FA8604-25-R-B022

Materials Handling System at Laughlin AFB, Texas 47 Flight Training Wing (FTW) MXD,
Buildings 65 and 68

Question Set #2

27 May 2025

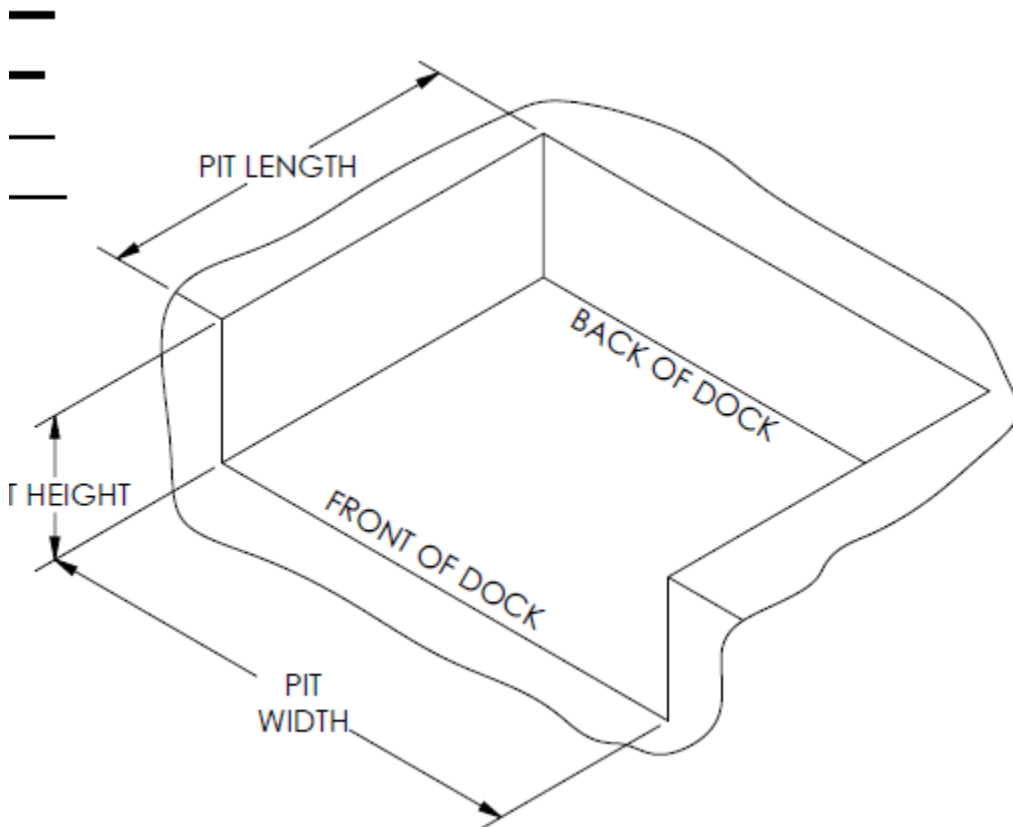
7. Can you provide detailed pics of the existing dock leveler and below the dock leveler? [Pictures provided herein.](#)
